REBUTTAL TESTIMONY

ILLINOIS COMMERCE COMMISSION

ILLINOIS POWER COMPANY d/b/a AmerenIP

Docket No. 10-0079

Docket No. 10-0079  
 ICCStaff Exhibit 3.0  
 Attachment A  
 ICC Docket No. 10-0079  
 ENG 4.06 Attach 5

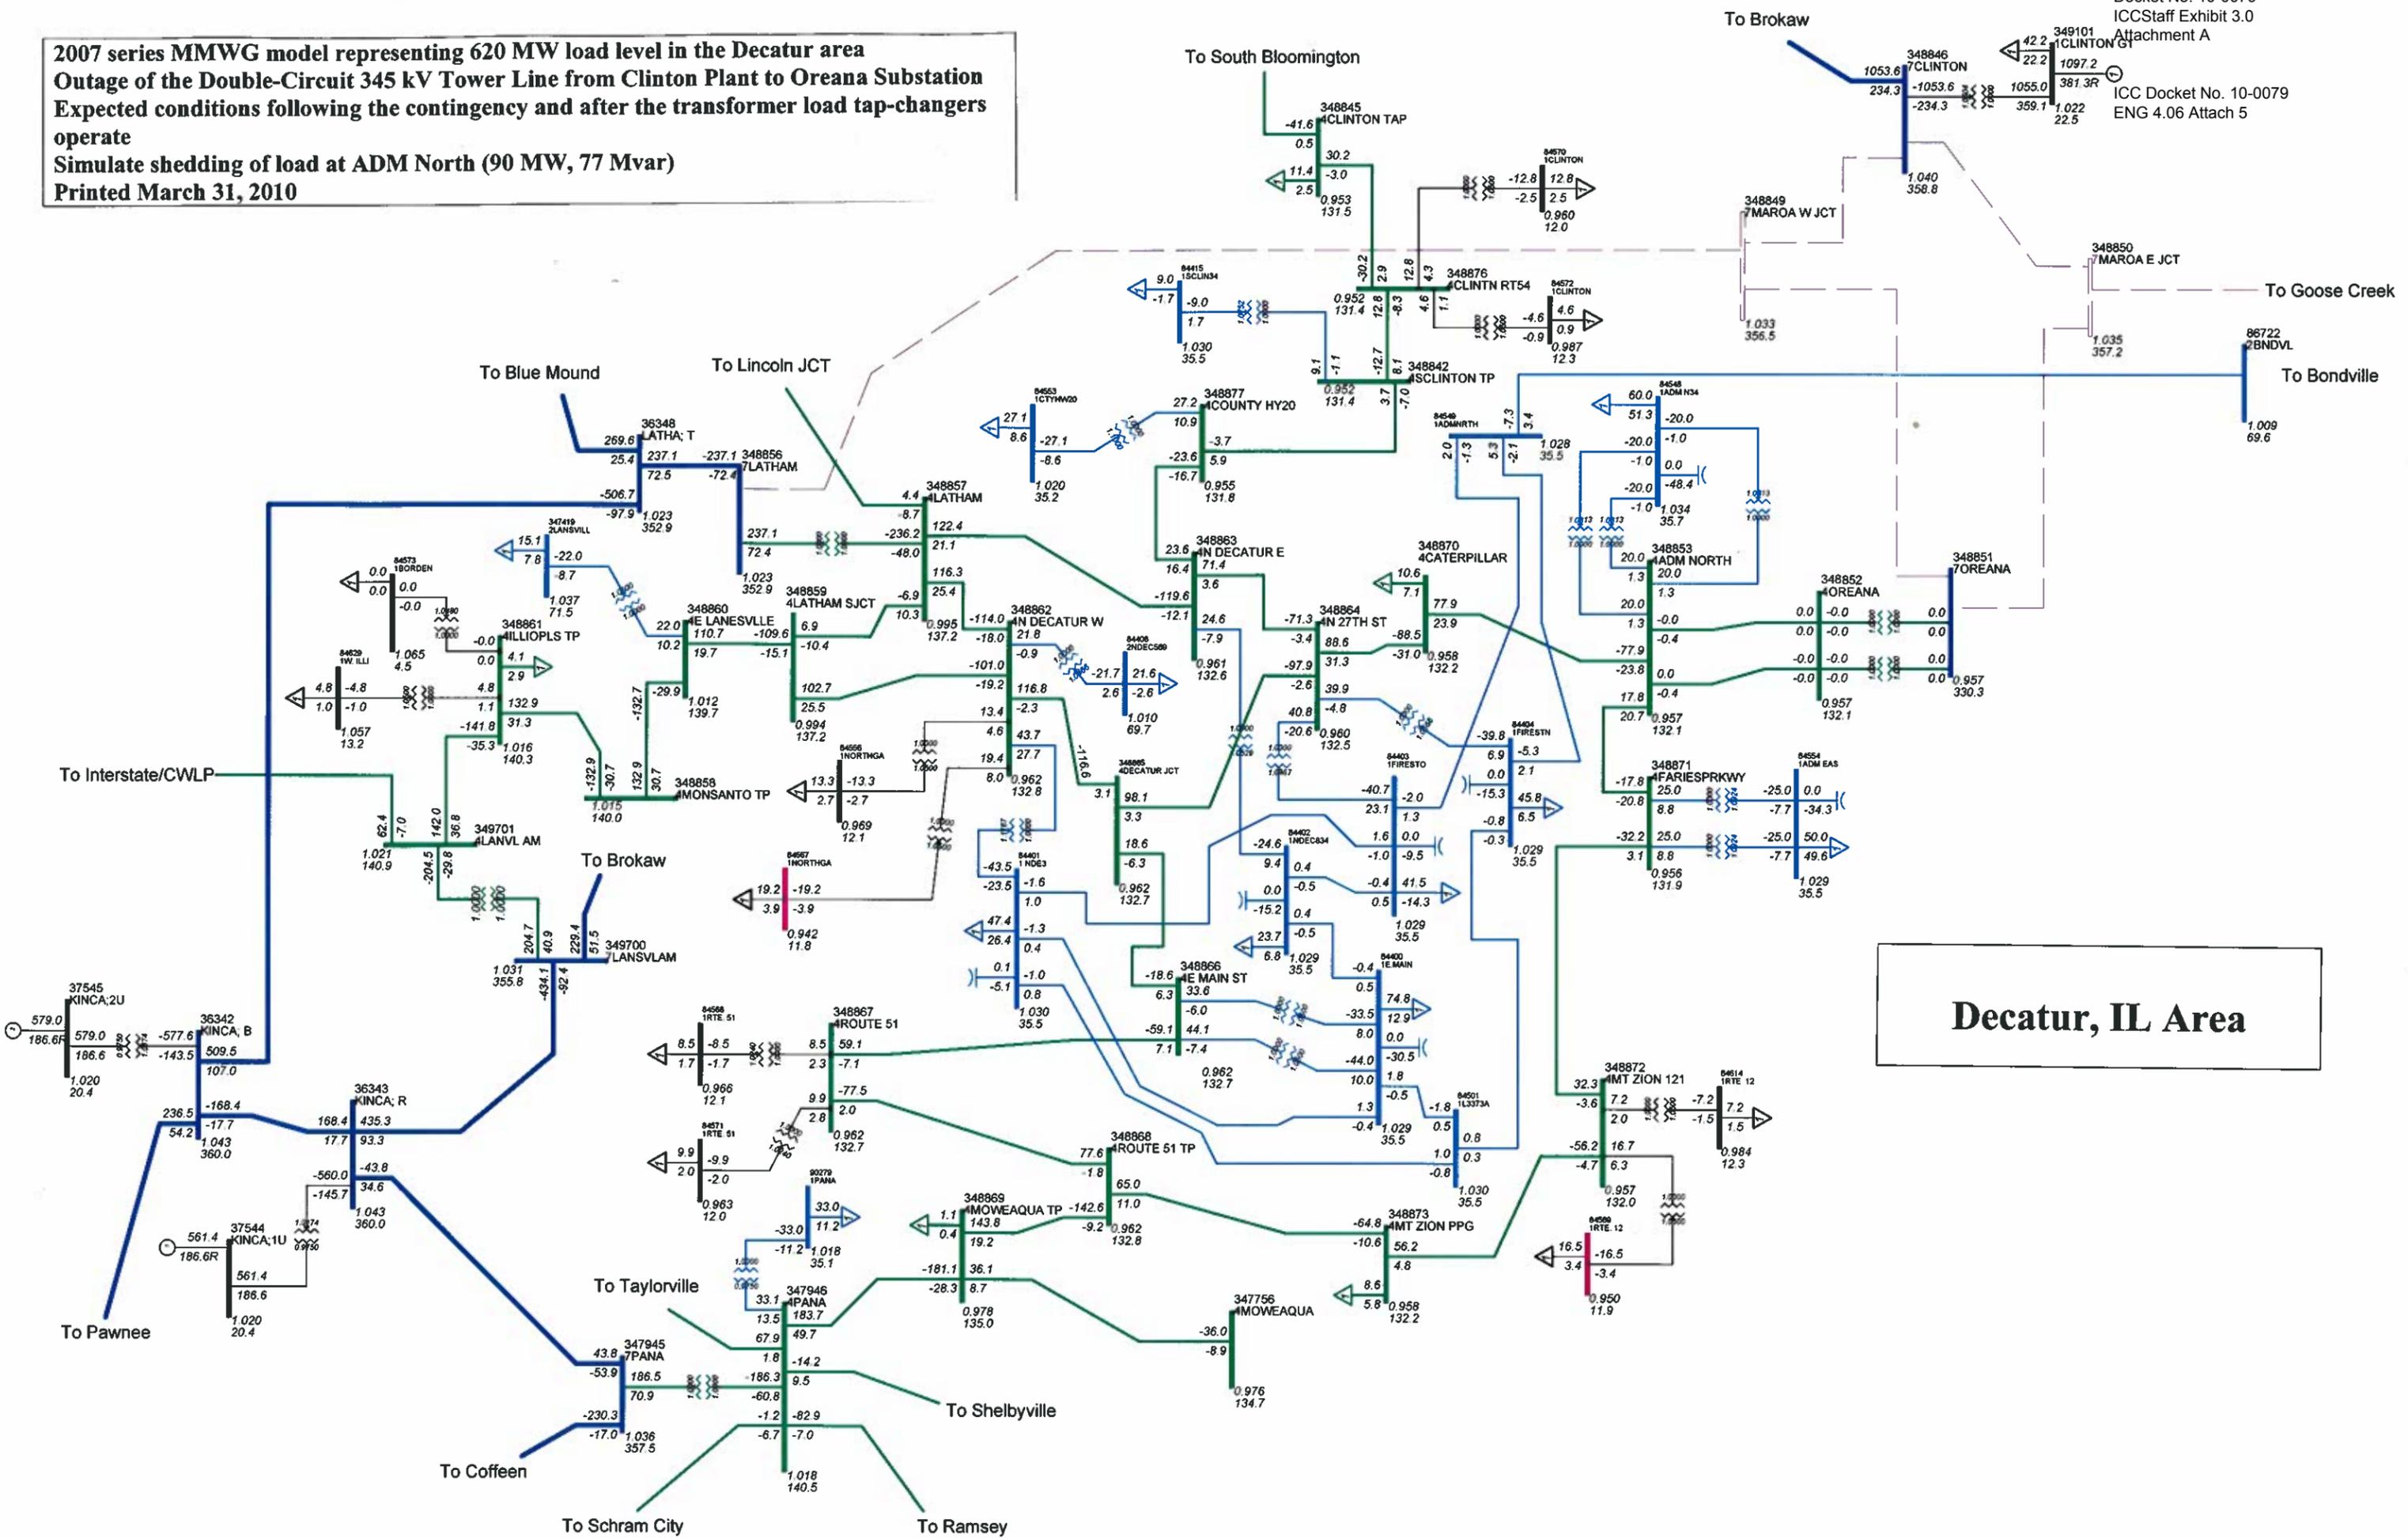
75 A. The aforementioned power flow model<sup>6</sup> that was provided as part of AmerenIP  
76 response to Staff data request ENG 4.06(d) models the Decatur area’s electric  
77 system under the following conditions:

- 78 • A load level of 620 MW by 2016;
- 79 • The outage of both the Clinton to Latham 345 kV transmission line and the  
80 Clinton to Goose Creek 345 kV transmission line;
- 81 • After the operation of the transformer load tap changers (LTC) to mitigate low  
82 voltage conditions; and
- 83 • After dropping a load of 90 MW to mitigate low voltage conditions.

84 The aforementioned model suggests that there will not be a need for the  
85 proposed project by 2016, because AmerenIP will be able to control the low  
86 voltage conditions in the Decatur area in the event of the outage of both Clinton  
87 to Latham 345 kV transmission line and the Clinton to Goose Creek 345 kV

88 transmission line. The model also suggests that, without the proposed project,  
89 AmerenIP will stay in compliance with Ameren Transmission Planning Criteria  
90 and NERC Standards in 2016.

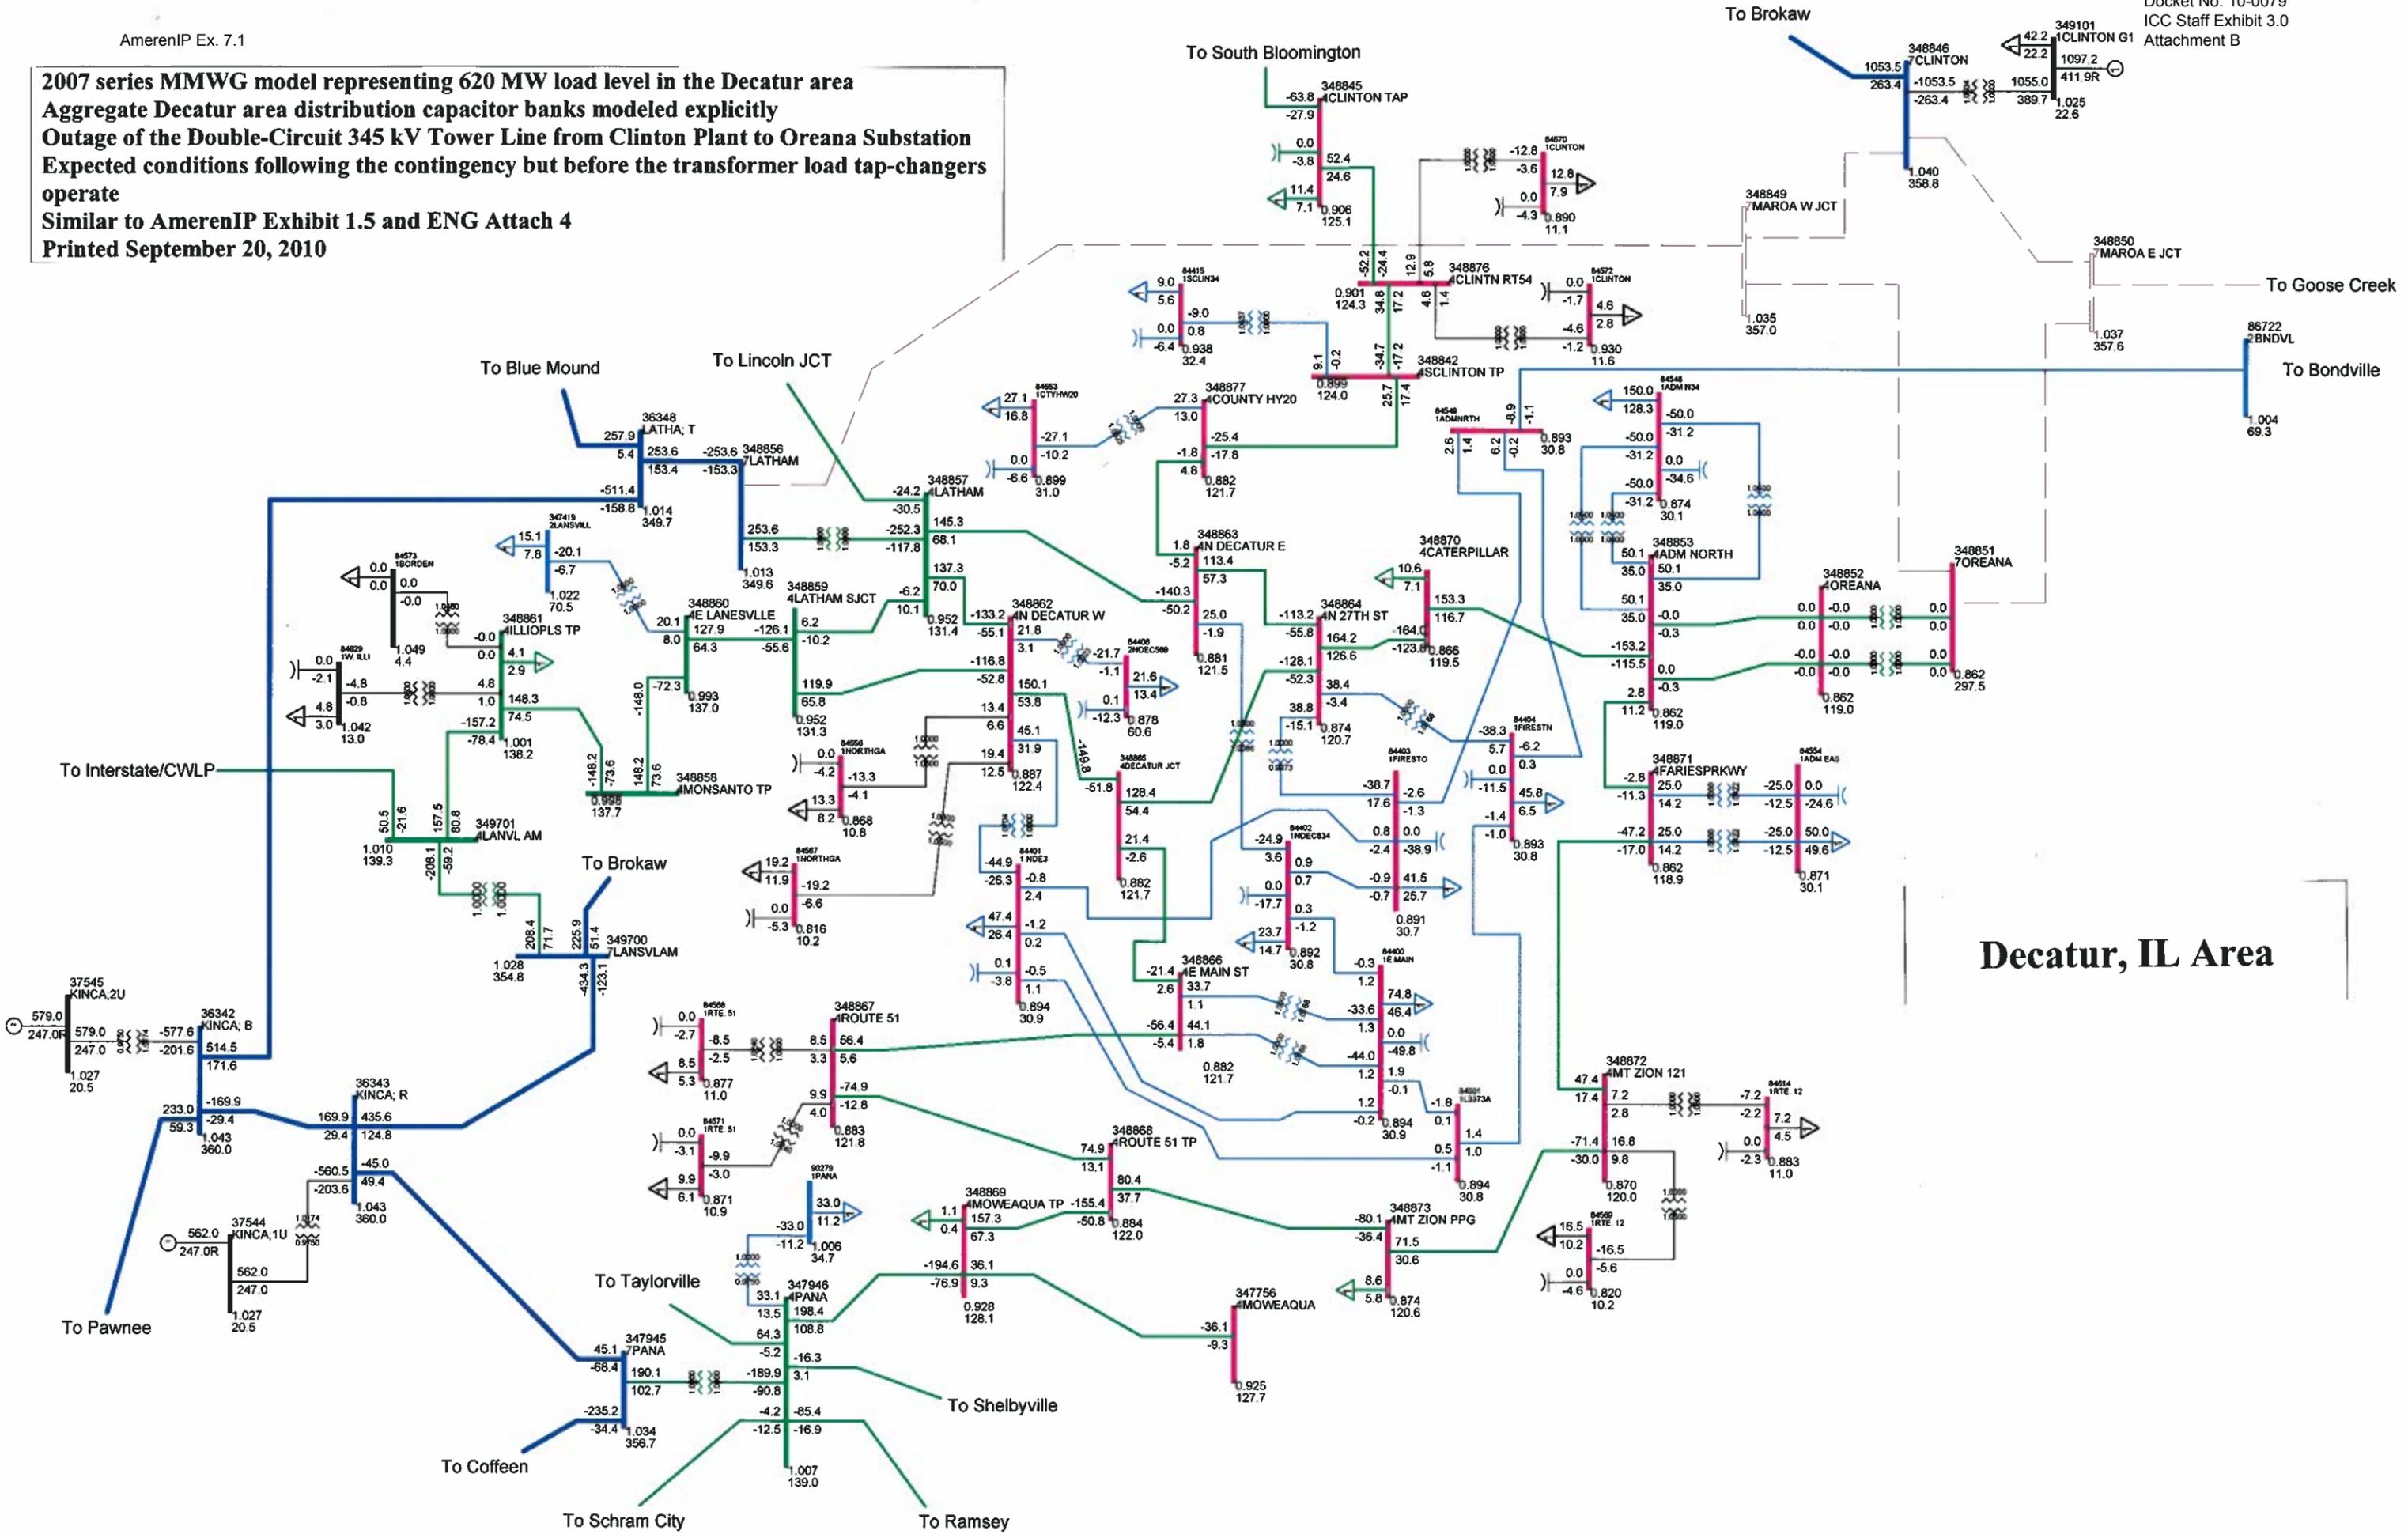
91 However, the new power flow model<sup>7</sup> models the Decatur area's electric system  
92 under the following conditions:

- 93 • A load level of 620 MW by 2016;
- 94 • The outage of both the Clinton to Latham 345 kV transmission line and the  
95 Clinton to Goose Creek 345 kV transmission line;
- 96 • Before the operation of the transformer load tap changers (LTC);
- 97 • No drop for any load to mitigate low voltage conditions; and
- 98 • More explicit modeling to some of the electric components (capacitors) on the  
99 underlying distribution system.<sup>8</sup>

108 conditions (*i.e.*, assuming dropping a load will not be doable timely),<sup>11</sup> and with  
109 explicit modeling to electric components called capacitors, as indicated in  
110 AmerenIP Ex. 7.1.

140 A. Yes.<sup>19</sup> Based on those levels, it is clear that there will be two buses with voltage  
141 levels far below the 85% of their original value and many buses with  
142 unacceptable low voltage levels.

145 A. Based on AmerenIP revised model and new assumptions, I conclude that the  
146 proposed transmission line is needed to comply with Ameren Transmission  
147 Planning Criteria. The proposed transmission line would hedge against low-  
148 voltage conditions that might happen in the event of the outage of the Clinton to
